Reference point for OMA_{outer} (comments #94, #62)

Adee Ran, Cisco

The comments

Figure 121–3—Example power levels P_0 and P_3 from PRBS13Q test pattern

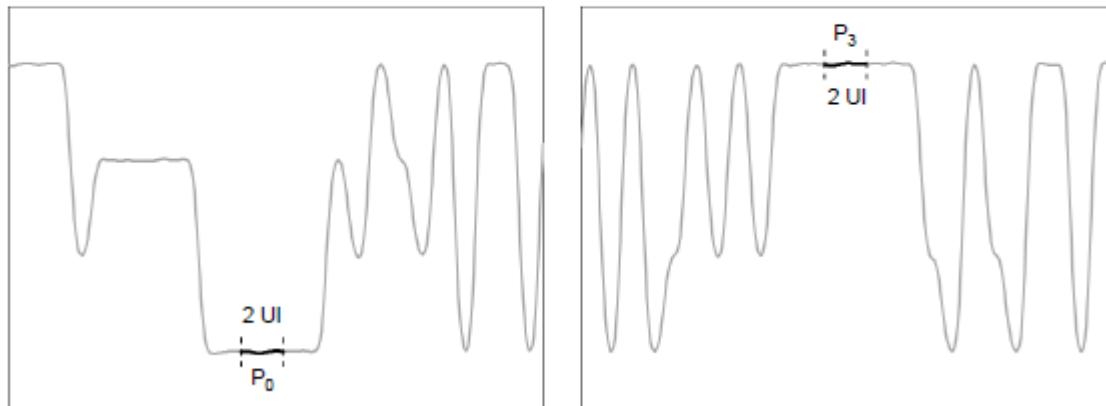
The measurement point (before/after equalizer) is not specified here - but the signal in Figure 121-3 is clearly equalized...

Figure 180-8—Example power levels P_0 and P_3 from PRBS13Q test pattern

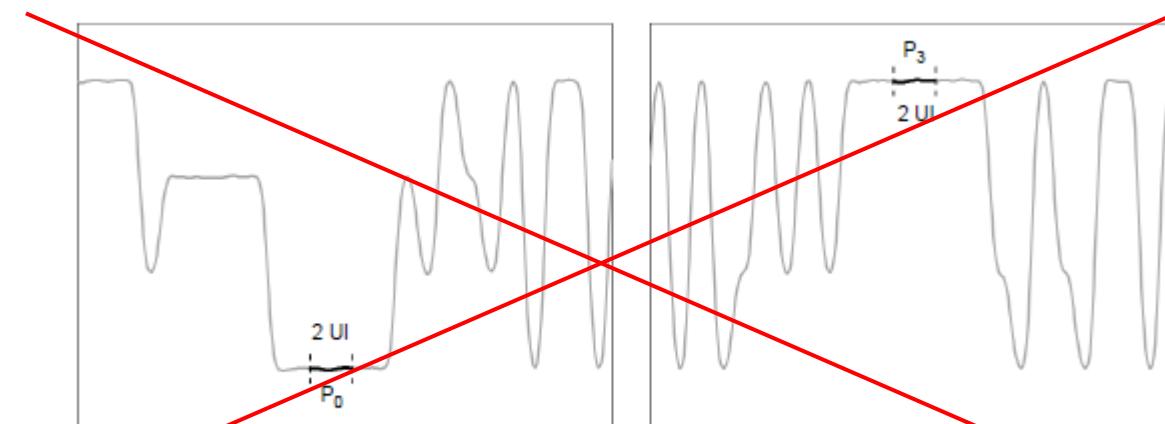
As noted in previous comments, the illustration of the signal in Figure 180-8 does not match this statement; the signal in the figure is fully equalized. Indeed, in a non-equalized signal, there will likely be no flat region in a 6-UI run (noting that the reference equalizer is longer).

Measuring **before** the reference equalizer (new specification) means the measurement region is not flat anymore...

This is what you expect to see **after** the reference equalizer – not **before** it (it can only be the same if the equalizer does nothing)

The measured P_0 and P_3 before equalization depend on the bandwidth, peaking, etc. of the Tx DUT, and **may be higher or lower than the DC levels**

This deviates from the original meaning of OMA_{outer} and results in ambiguity (any possibly noisiness) of the result
Indirectly, it changes the meaning of $RINxxOMA$ and receiver sensitivity
Many people are likely unaware of this

Change "at the output of the reference receiver defined in 180.9.2" to "at the output of the reference equalizer defined in 180.9.6.3".

Figure 180-11—Illustration of the TDECQ measurement

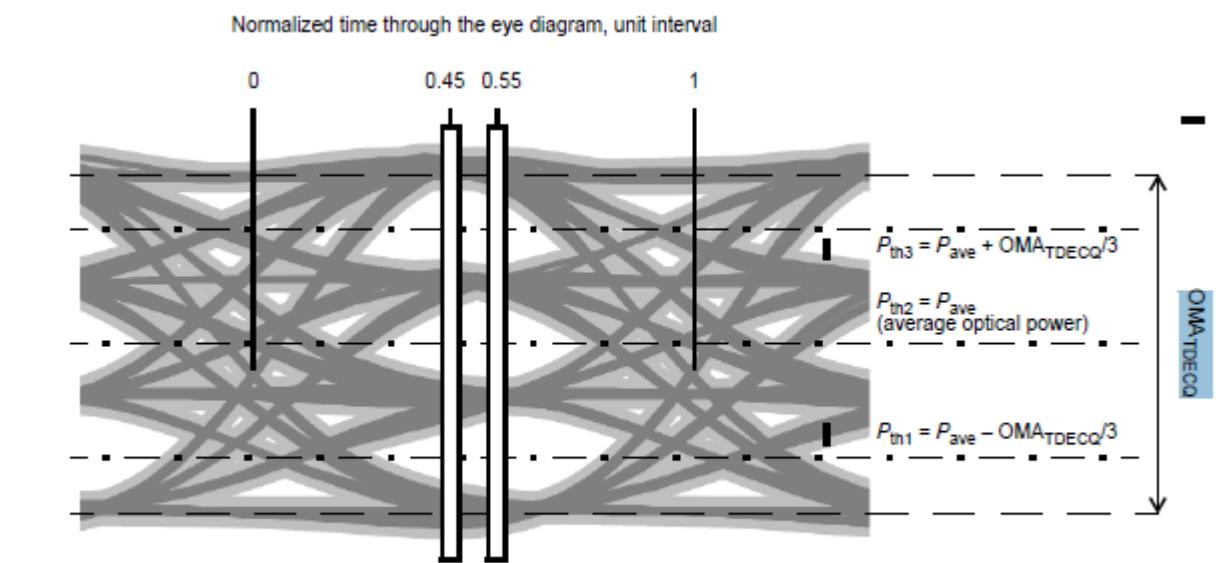
This may be worth correcting; OMA_{TDECQ} is measured at the equalizer output

This matches the open eye diagram illustrating the TDECQ measurement

Should we redefine OMA_{outer} to be at the output of the reference equalizer (merge with OMA_{TDECQ})?
